**Public Summary: Final Removal Action Landfill Cap Closeout Report
Parcel E-2, Hunters Point Shipyard, San Francisco, California,
February 7, 2005**

Removal Action Landfill Cap Closeout Report Parcel E-2

Hunters Point Shipyard
San Francisco, California

February 7, 2005

FIGURE 2
LATERAL EXTENT OF INTERIM CAP AND BURN AREA
Final Removal Action
Landfill Cap Closeout Report

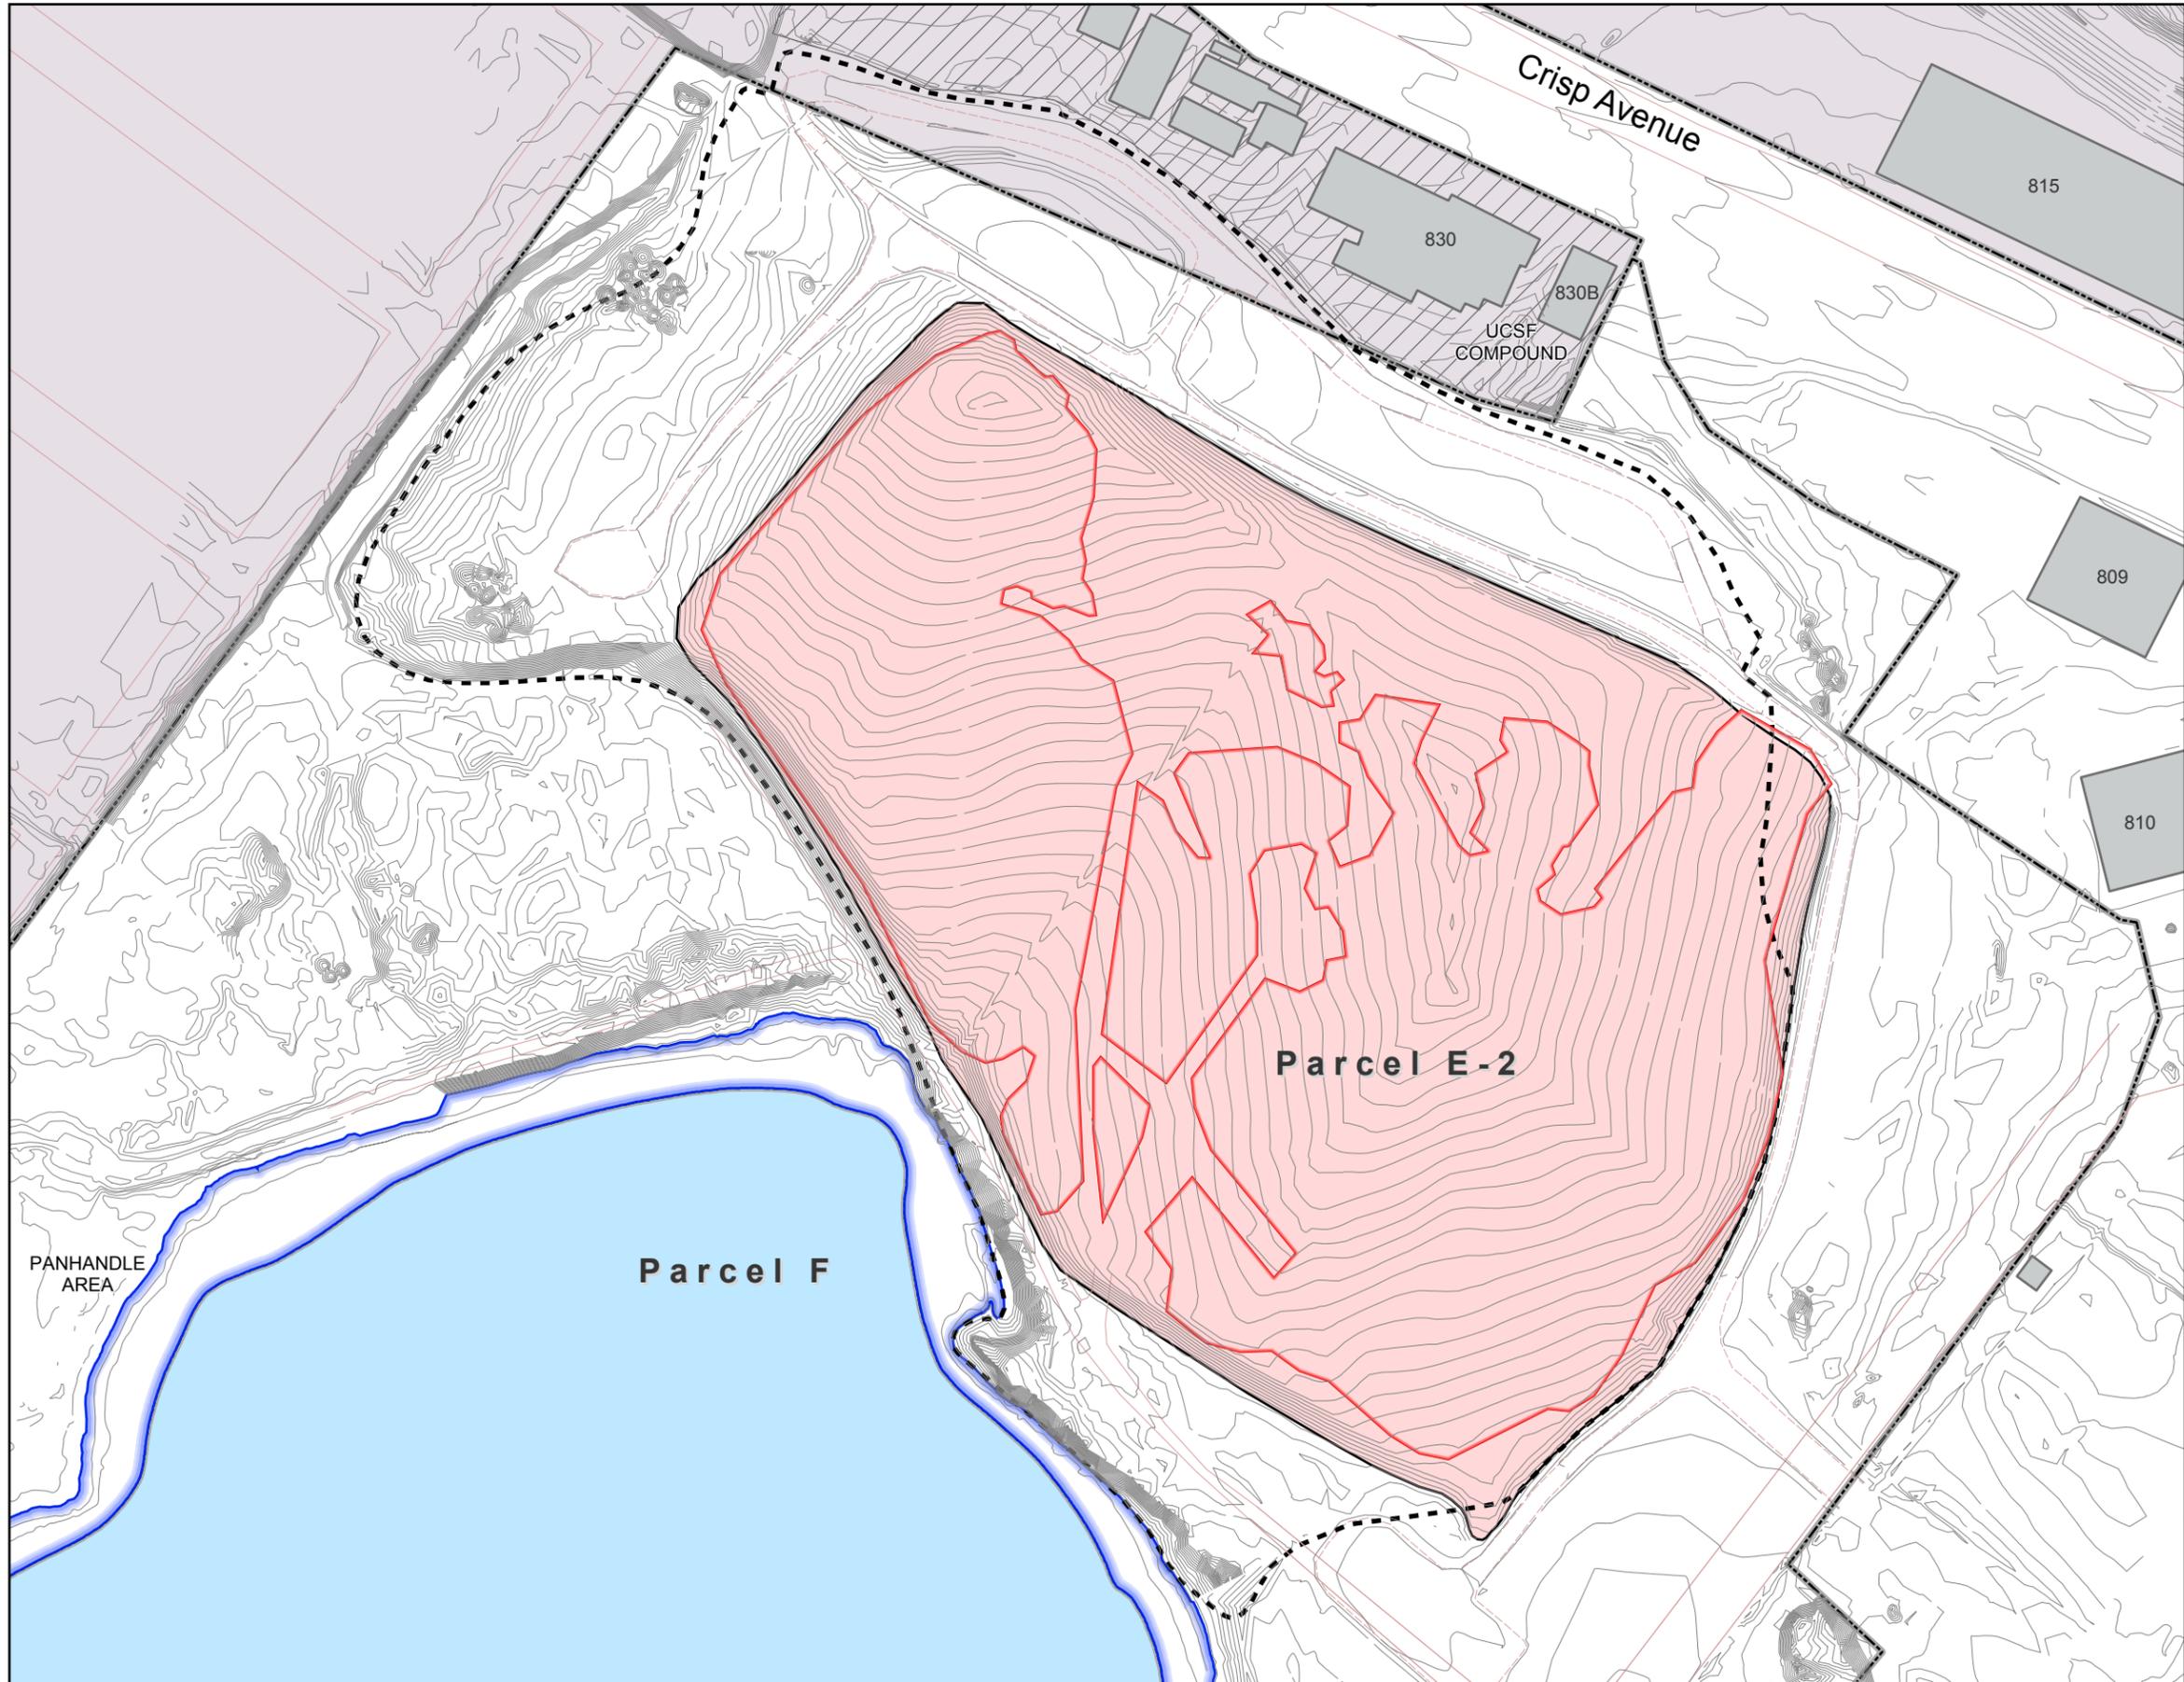
11. Comment: **Figure 2: The installation of the cover system should completely envelop the landfill waste. However, the edge of the waste goes beyond the coverboundary.**

The text is confusing as it first states that ongoing site characterization has been conducted to delineate the extent of waste. The text then refers to Figure 2, which shows the extent of the new landfill cap in relation to the burned surface area but does not illustrate the extent of waste. The text and Figure 2 should be revised to make clear that the waste extends beyond the cap and burned area or that the cap/burned area does not cover the entire landfill. In addition, the blue colored contour line is not explained in the legend for Figure 2.

Response: The Navy has revised the text and [Figure 2](#) to clearly illustrate that the cap and burned area do not cover the entire Landfill.

FIGURE 4
FINAL TOPOGRAPHY

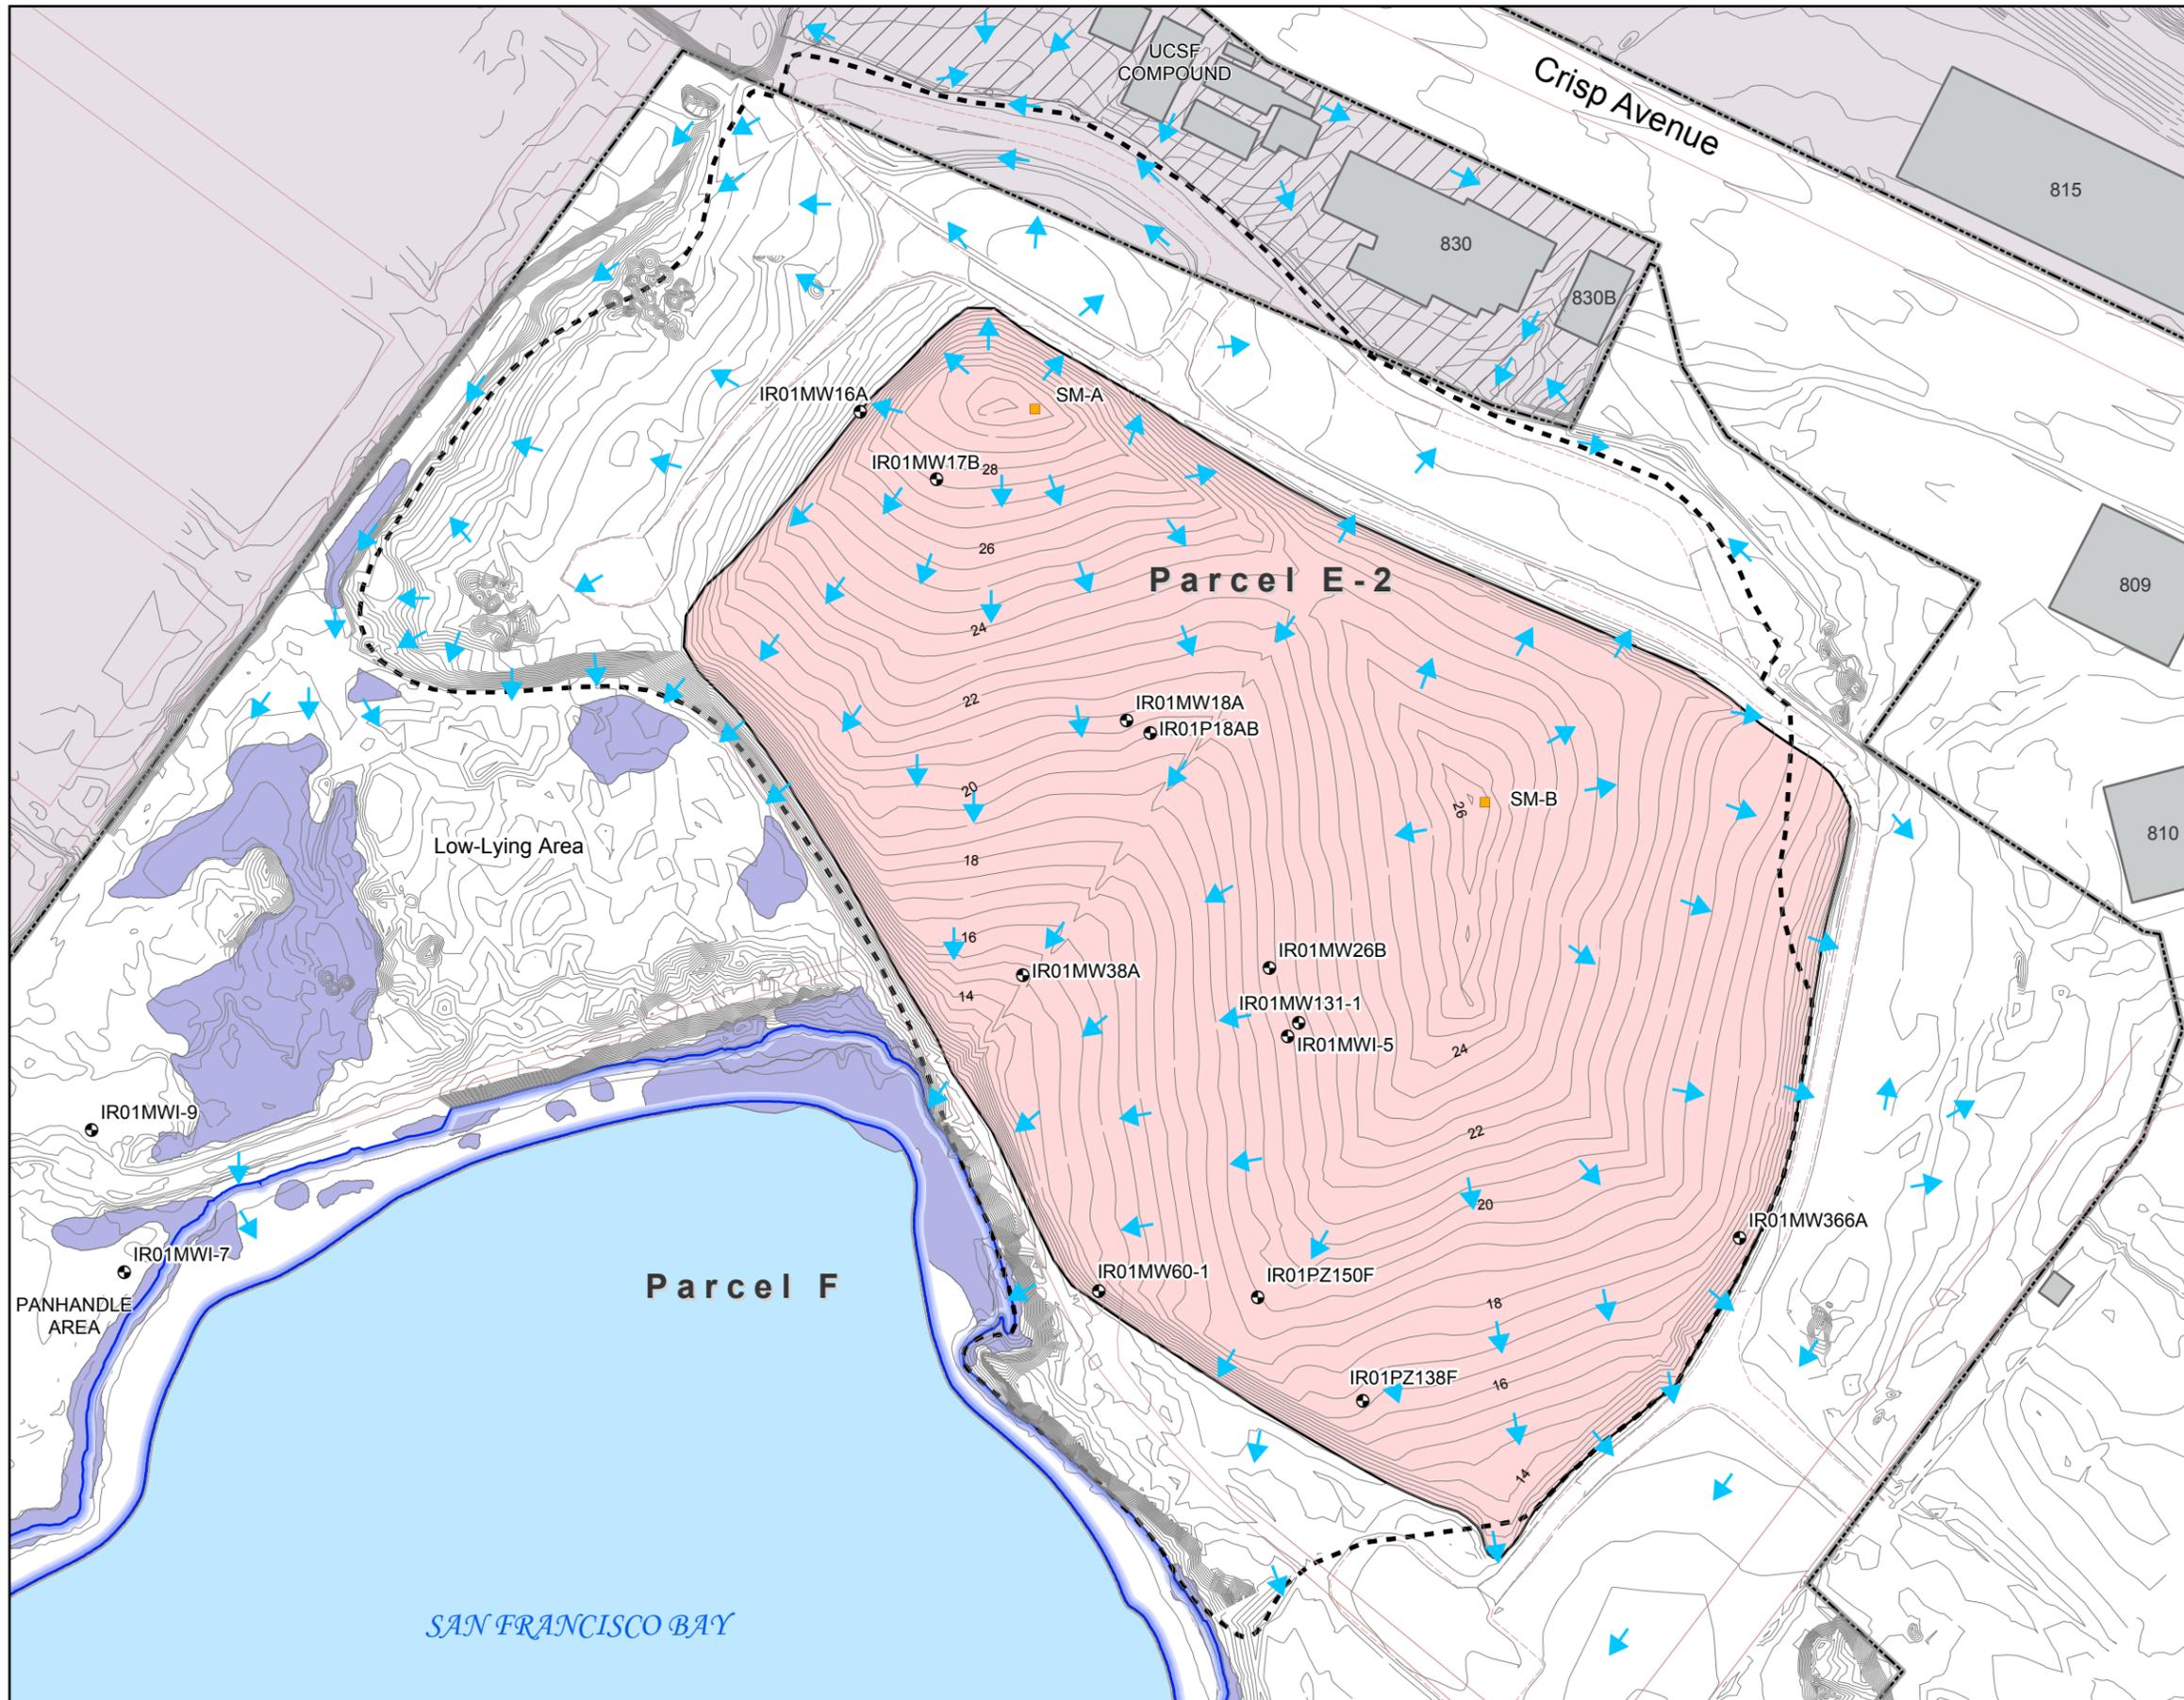
10. Comment: **Figure 4: The report should include:**

Response: The Navy installed riprap to prevent erosion along the concentrated flow path in the center of the cap; it has been performing satisfactorily. In addition, a storm water discharge management plan has been prepared to address overall erosion concerns within the landfill area ([Tetra Tech 2003b](#)). The anchor trench is typically a 2-foot by 1-foot trench in which the liner and geotextile are placed before backfilling. Section A of Figure 4 of the draft final report shows a typical anchor trench.
